WEST/CENTRAL AREA COMMITTEE MEETING –
Pre-Committee Amendment Sheet

ITEM: APPLICATION REF: 13/1360/FUL

Location: 89 Barton Road

ITEM: APPLICATION REF: 13/1280/FUL

89 Barton Road, Cambridge
Perspective View from Lake

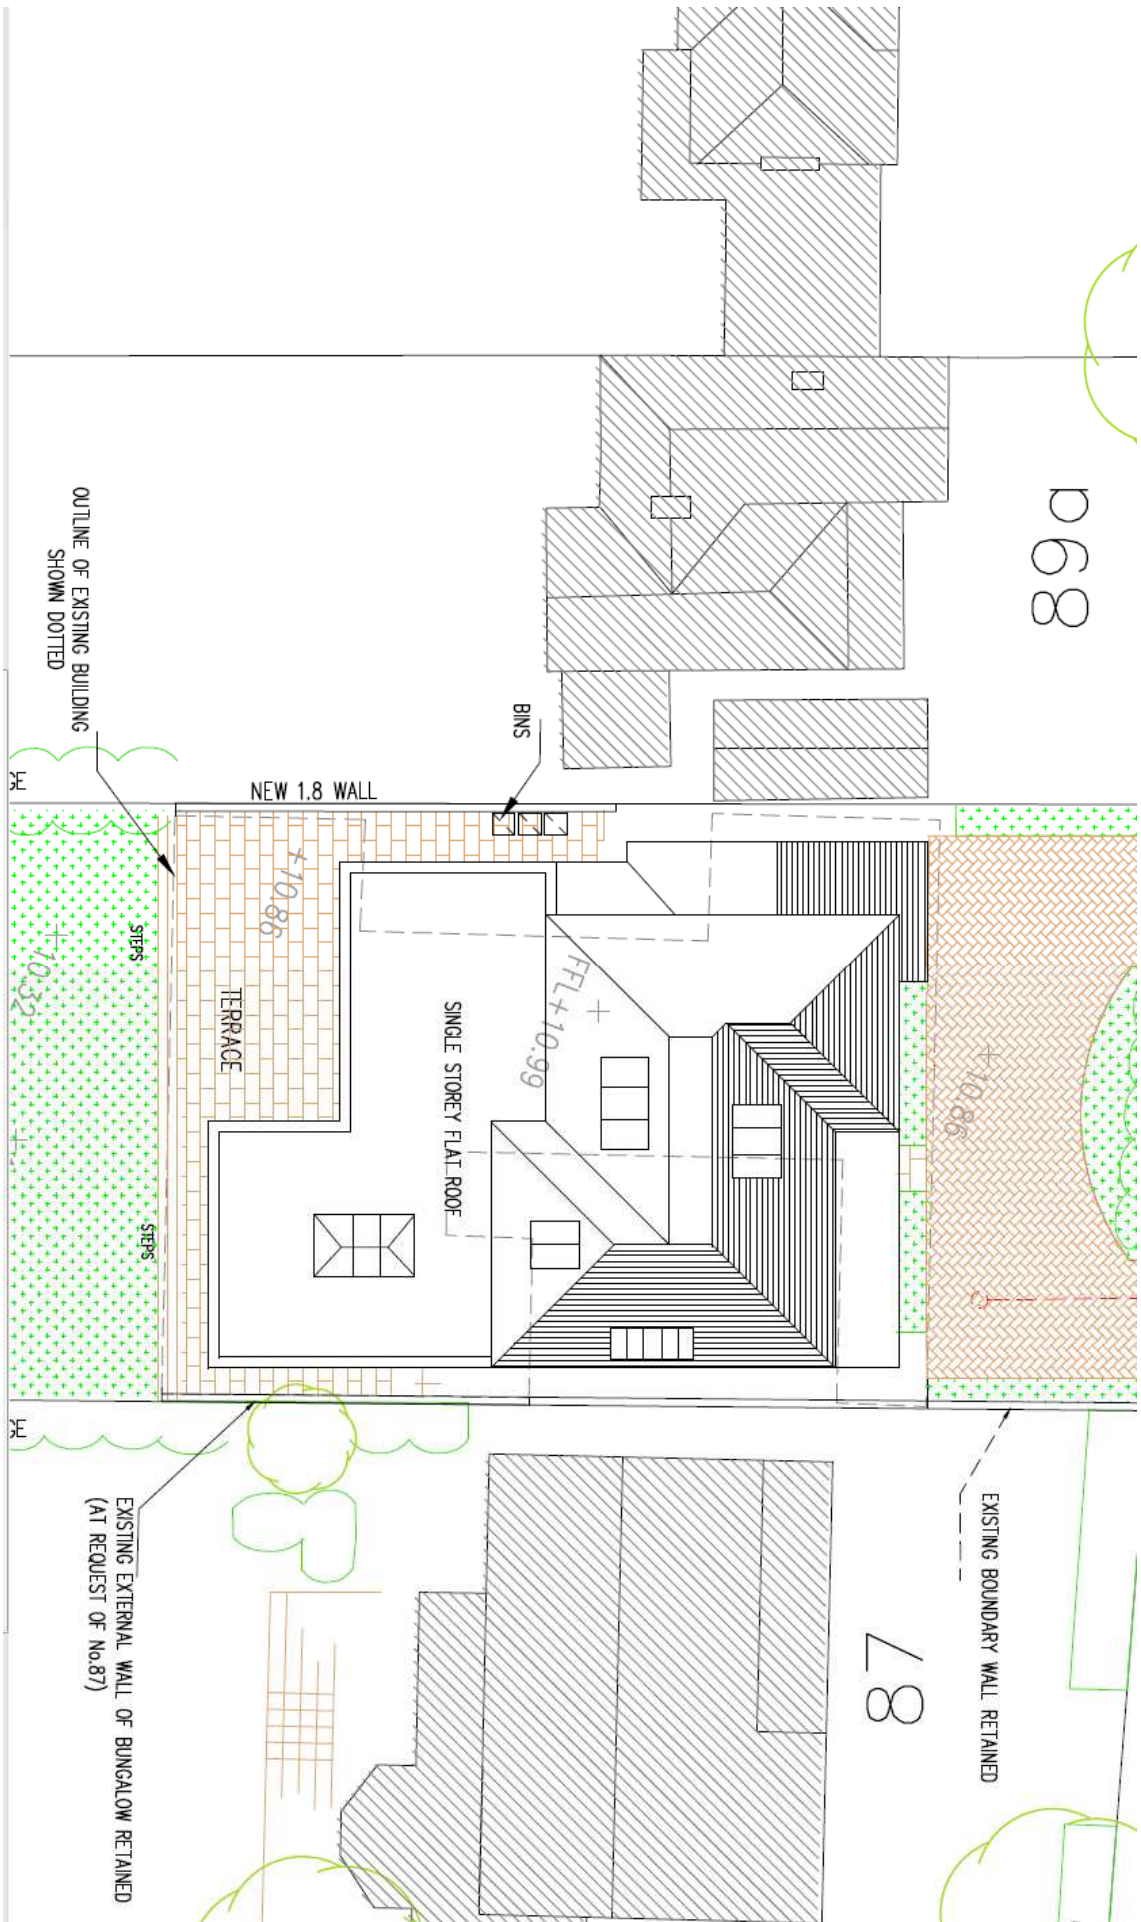
Barton Road Pool (lake) is a designated County Wildlife Site (CWS). The reason for designation is that it is on the JNCC Invertebrate register with interesting Lepidoptera, associated with the reedbeds, and a nationally notable Musk Beetle *Aromia moschata*.

The proposed replacement dwelling is not within the designation, which follows the lake boundary, and is unlikely to impact on the invertebrate interest of the site. However, due to the sites proximity and direct frontage to the CWS I feel Local Plan policy 4/6 (Protection of Sites of Local Nature Conservation Importance) requires a phase 1 habitat and protected species assessment, including recommendations for any necessary mitigation, and potential enhancements (for example integral swift and bat boxes within the new building) to be made prior to determination. Certainly, the water body is likely to attract a significant number of foraging bats and the building proposed for demolition should be surveyed for potential roosts.

It would appear that no trees are being affected by the proposals and there is no mention of landscaping or external lighting. It would be good to clarify these issues as they have the potential to either adversely affect or enhance the sites biodiversity value.

In light of the above, the applicant has commissioned a phase 1 habitat survey. Officers will update verbally at the Committee.

The suggested landscape conditions will adequately cover any potential external lighting of the garden. There is however no intention to install any such lighting.

TITLE
 Ground Floor Massing Plan

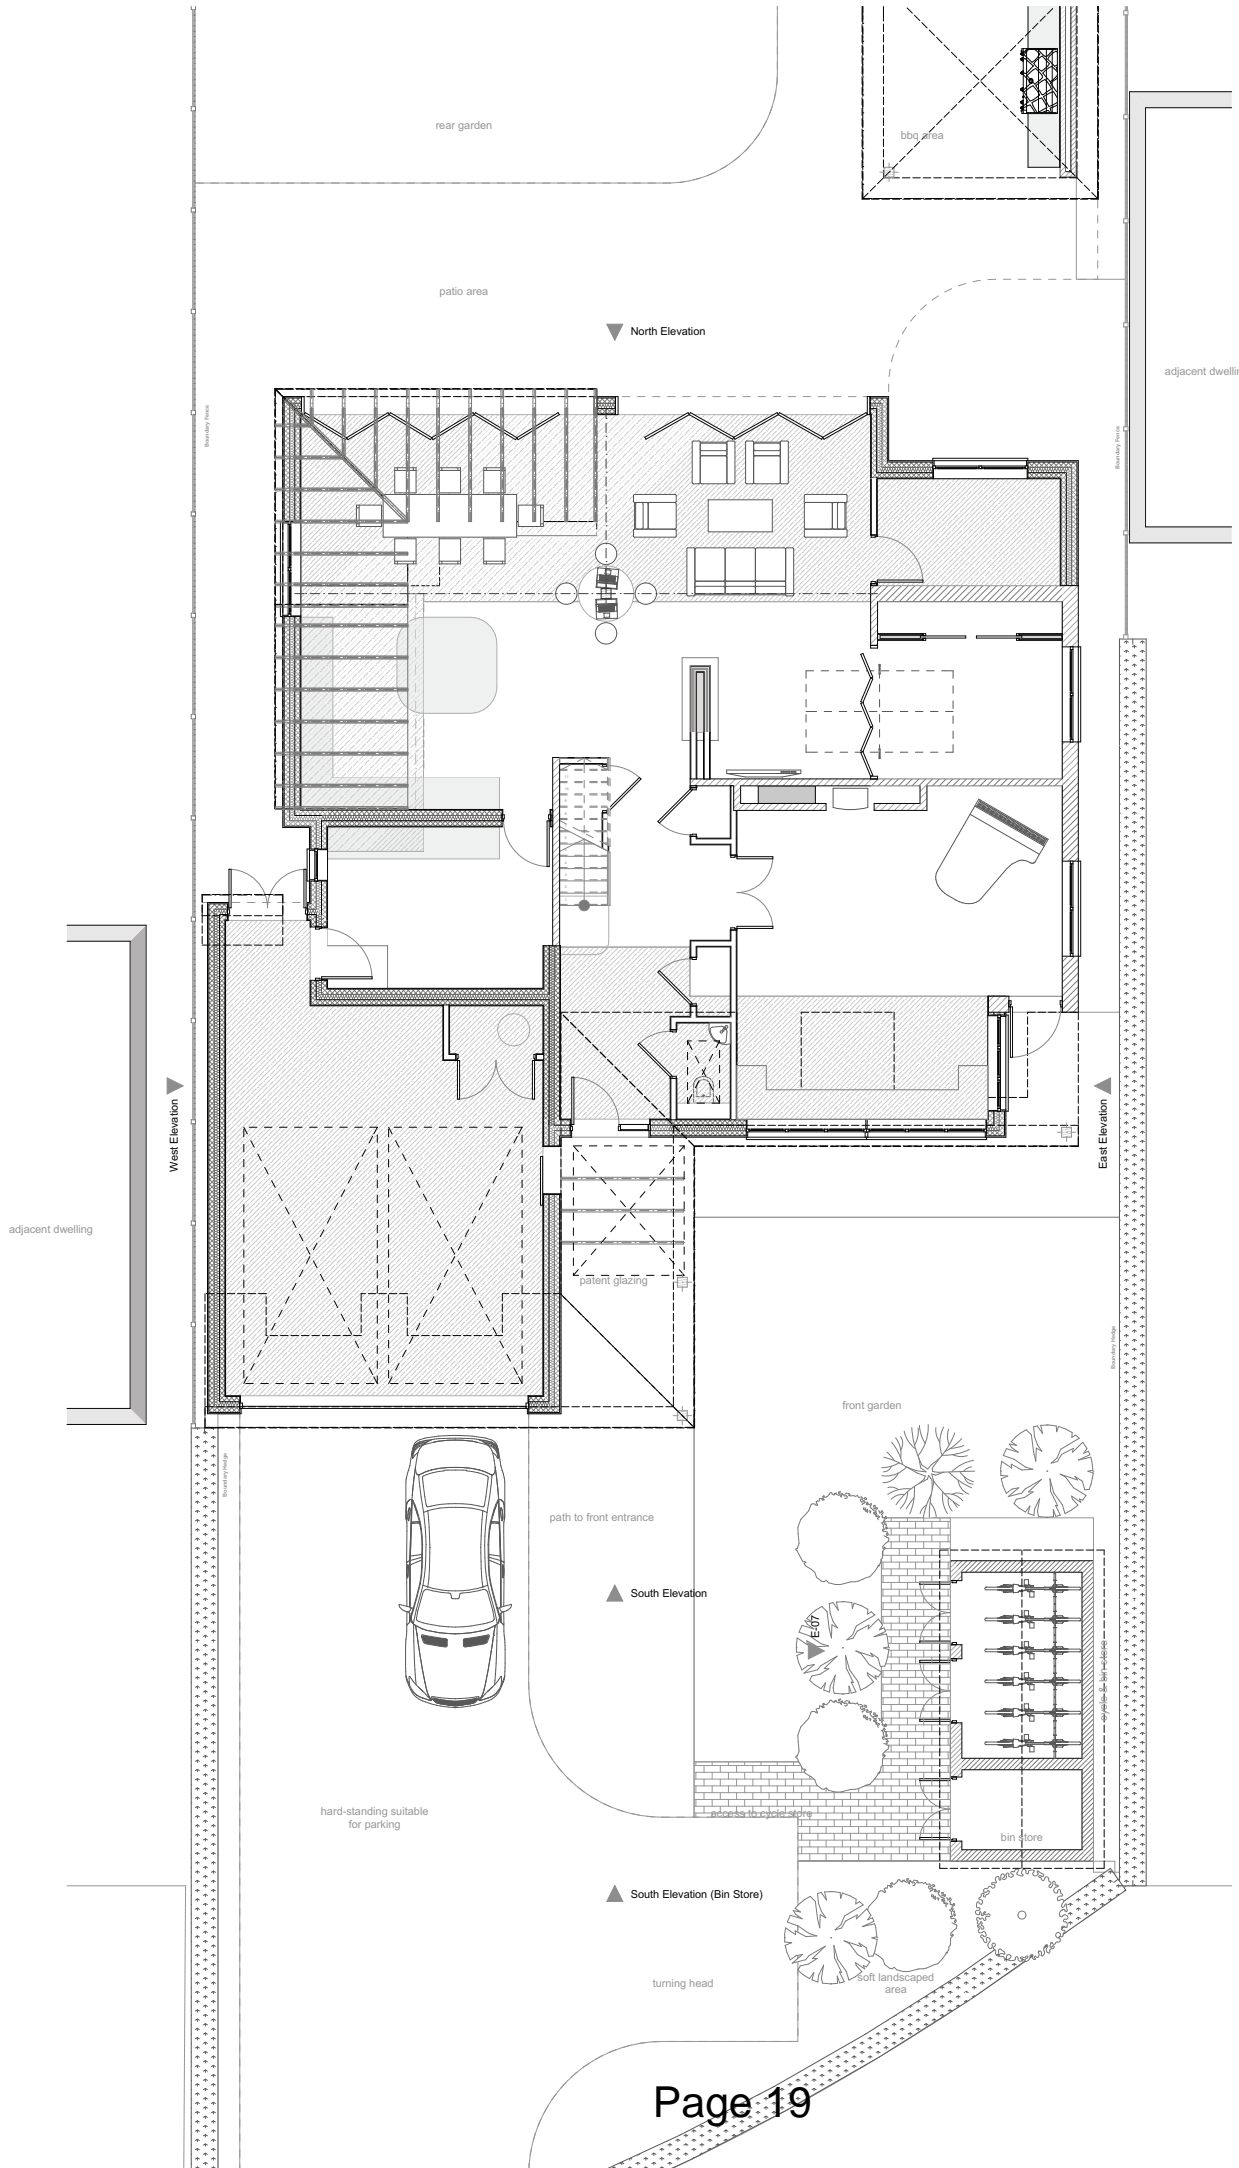
Visual perspectives of the west and front of the proposed development and a massing floor plan have been submitted at officers' request. These details give the proposed development a sense of visual perspective from the street scene and show that the massing of the development is acceptable. They are put forward for illustrative purposes.

- openings, create a terrace effect and risk of damage from future floods
- The proximity of garage would block light in east facing window, affect foundations.
- Overlooking of front garage area from bedrooms above garage
- Greater risk of flooding and flood damage
- The proposal would be contrary to policy 3/14 and draft 2014 plan policy 58.

According to the NPPF and the latest standing advice from the EA, non-residential extensions under 250sqm (footprint) are permitted if the floor levels are the same and flood proofing and resilience have been incorporated into the design or the floor levels are 300mm above the 1 in 100 year level.

This needs to be demonstrated for it to be compliant with the NPPF. Because of the proximity of the existing garage and conservatory, the new situation does not appear to make the situation significantly worse.
